Marine Management Organisation

MMO Reference: DCO/2019/00005
Planning Inspectorate Reference: EN010117
Registration Identification Reference:20045232

Planning Act 2008, E.On Climate and Renewables UK Ltd, Proposed Rampion 2 Offshore Wind Farm Order

This document comprises the Marine Management Organisation's ("MMO") initial comments in respect of the above Development Consent Order ("DCO") application ("DCO Application") in the form of a relevant representation.

Figure 2: Kingmere MCZ “loud Boat” in relation to piling taken from Appendix 8.3 Underwater noise study for sea bream disturbance (below).

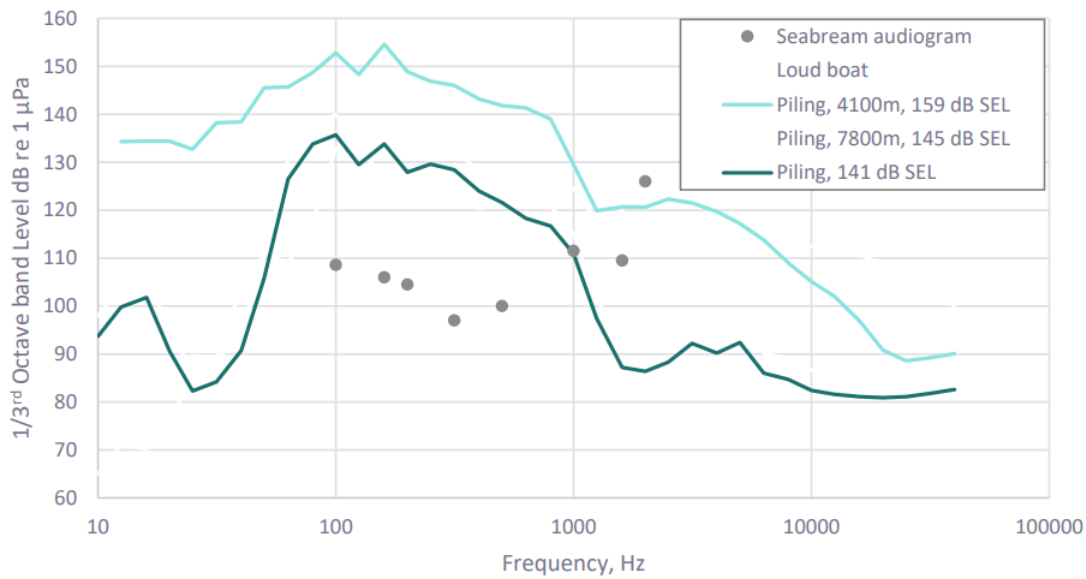
4.7.16 **Section 5 Impact of piling noise at Kingmere MCZ:** Figure 5 is missing the spectra for loud boat noise and piling at 7,800 m.

4.7.17 Figure 2 in Annex 3 (Figure 5 from the Applicants document) equates measurements made using two different metrics:

“An additional frequency spectrum has been included on Figure 5 that adjusts the 7800 m pile strike down to an equivalent noise level of 141dB SELss. It can be seen that this is only slightly higher than the “loud boat” spectrum. Therefore, at

Since an SELs of, e.g., 141 dB re 1 $\mu\text{Pa}^2\text{ s}$, may in fact include instantaneous sound pressure levels much greater than 141 dB re 1 μPa , hence exceeding the audiogram threshold. In other words, the piling noise levels are likely to exceed the seabream audiogram to a significantly greater extent than Figure 5 suggests.

Figure 3 & 4: Proposed zoning methods taken from the In Principle Sensitive Features Mitigation Plan

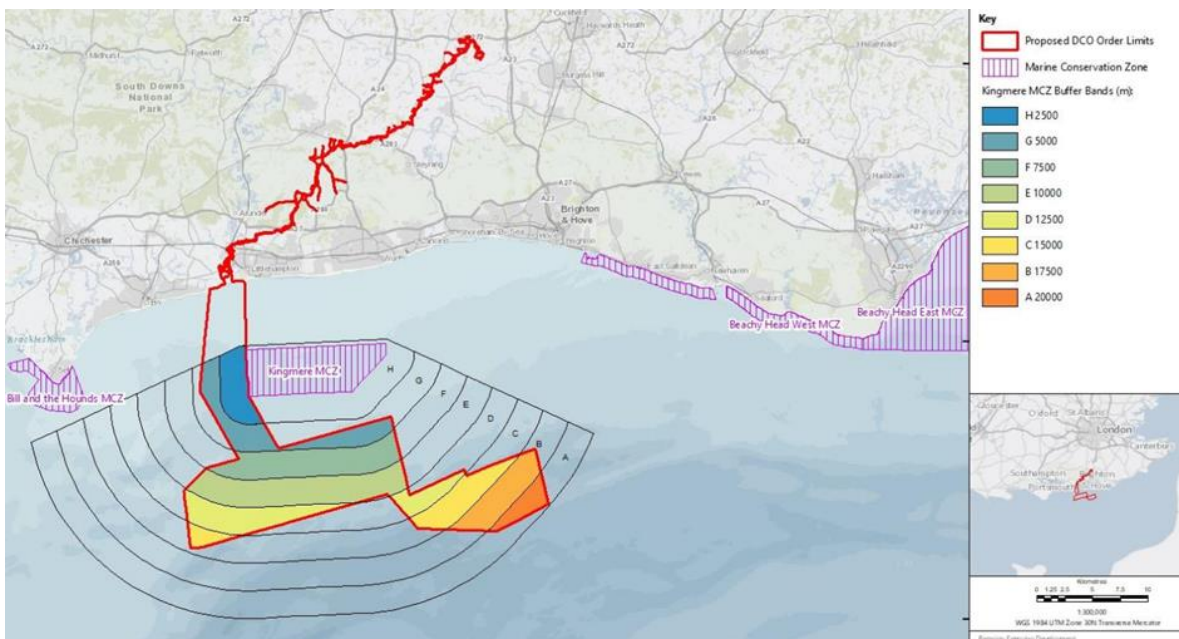
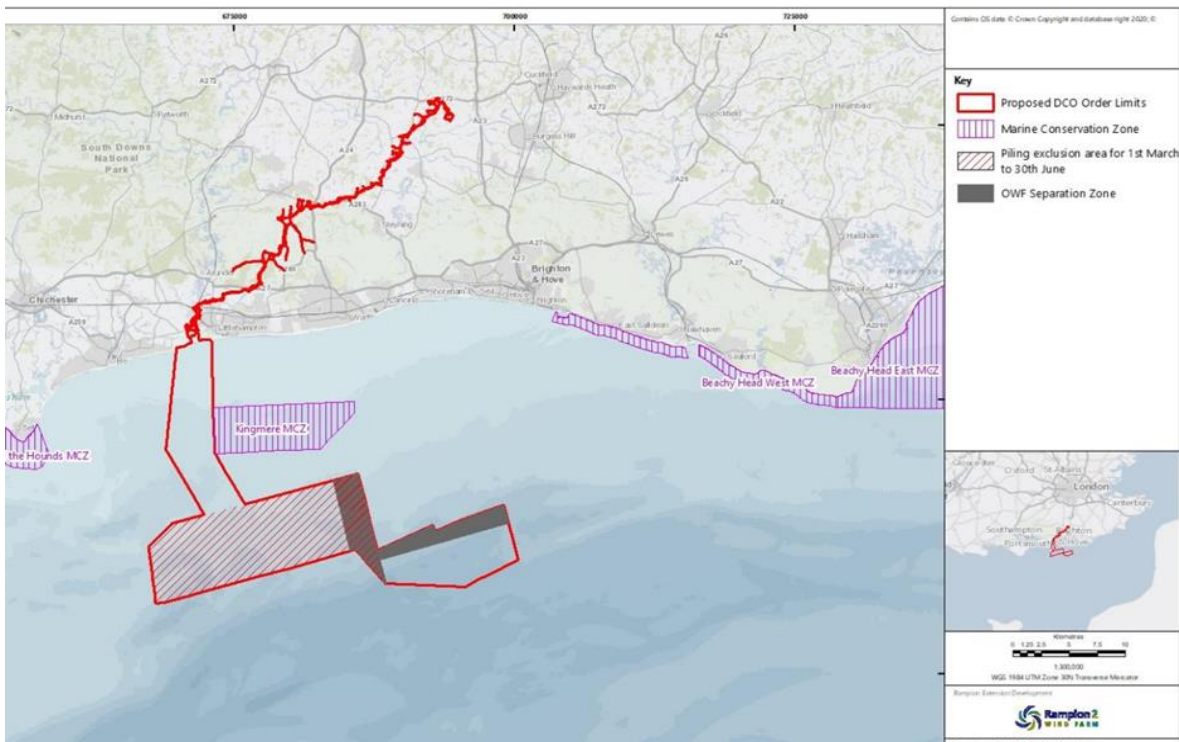
4.6.56 **During 1st March to 30th June:** The piling exclusion area will encompass the western part of the Array area, and no piling will therefore be undertaken in the western part of the Array (Figure 1, below). Piling in the eastern part of the Array area will be subject to mitigation using the combination of a low noise hammer technology and double bubble curtain (DBBC). Piling in eastern part will commence in the part of the array furthest from the Kingmere MCZ (in the southeast corner), and detailed scheduling of piling locations will be determined once the layout of WTGs and substations has been finalised.

- During March to June, the piling exclusion zone area will be extended to encompass the western part of the offshore Array. No piling will therefore be undertaken in the western part of the Array as shown in Figure 5-14 (Figure 3 of Annex 3). The MMO believes the proposal to extend the piling exclusion zone to the western part of the array is reasonable. Overall, we support the more generic zoning as per Figure 5-14, rather than the small arbitrary piling exclusion zone/s.

- 5.7.14 It is not clear what the dark shaded area is in Figure 5-14 – the OWF separation zone. Please could this be made clearer.
- 5.7.15 Whilst there is no requirement for a spatial zoning plan for the remainder of the year, MMO notes that the Applicant will continue to mitigate piling noise. The Applicant will propose to utilise at least one offshore piling noise mitigation technology. The MMO would reiterate that provided the Applicant commits to using noise abatement technologies which achieve the greatest amount of noise reduction, then we could support this proposal.
